**RE: Comments of Turner Ranch Properties, L.P. on the Draft Environmental Impact Statement for the Copper Flat Copper Mine**

**COMMENTS ON THE DRAFT ENVIRONMENTAL IMPACT STATEMENT FOR THE  
COPPER FLAT COPPER MINE**

**PREPARED BY THE NEW MEXICO ENVIRONMENTAL LAW CENTER (“NMELC”)  
ON BEHALF OF TURNER RANCH PROPERTIES, L.P. (“TRP”)**

**Figure 17: Snapshot of a portion of Figure 13 in Jones (2015) showing drawdown for the 30,000 tpd scenario, end of mining.**

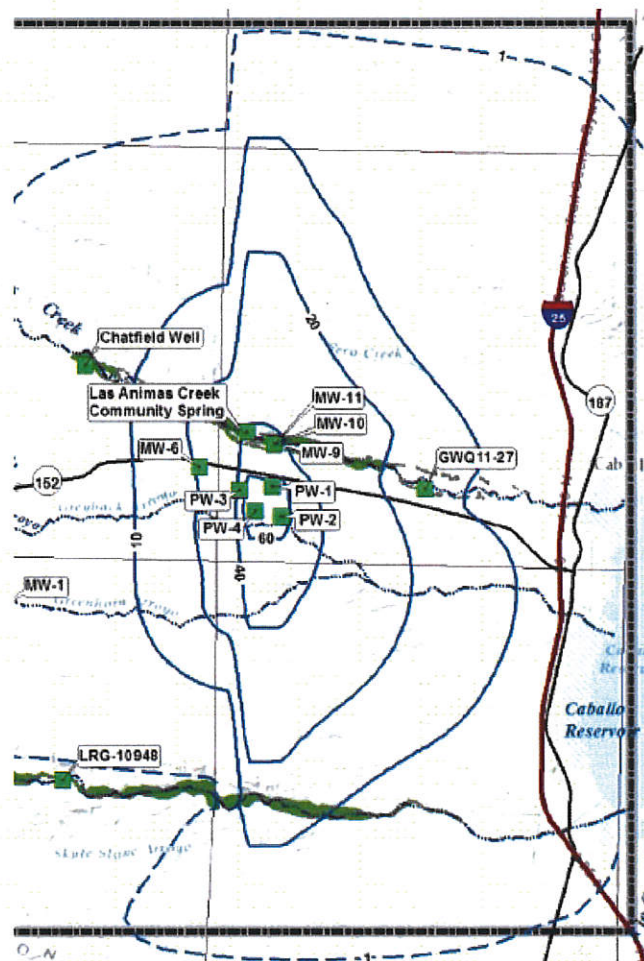
Further west, a larger drop coincides with fault 3. Just south of Hwy 152, the groundwater table drops at least 300 feet (Figure 17). However, only in layer 2 does the fault end at Hwy 152. The substantial

Figure 18: Figure 6.6 from Jones et al. (2013) showing the natural boundary conditions specified for the model simulation.

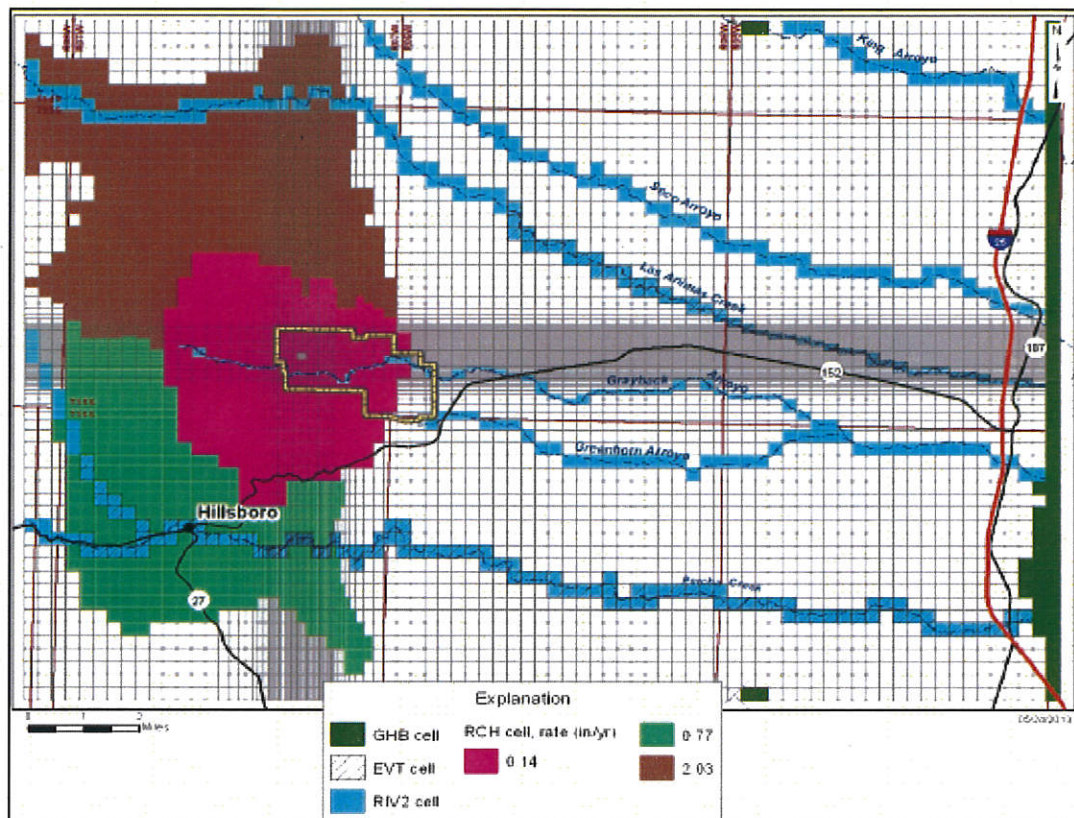
A GHB is also used to simulate the Rio Grande River and reservoir, as seen in the green cells on the east side of Figure 18, herein. The report does not specify this, but the MODFLOW input files show that this boundary occurs only in layer 1. This has the effect of driving flow from the lower to the uppermost layer, which is just 100 feet thick in this location. It also creates a backwater and higher gradient in layer 2 than would occur if the groundwater could discharge directly from layer 2 into the reservoir.
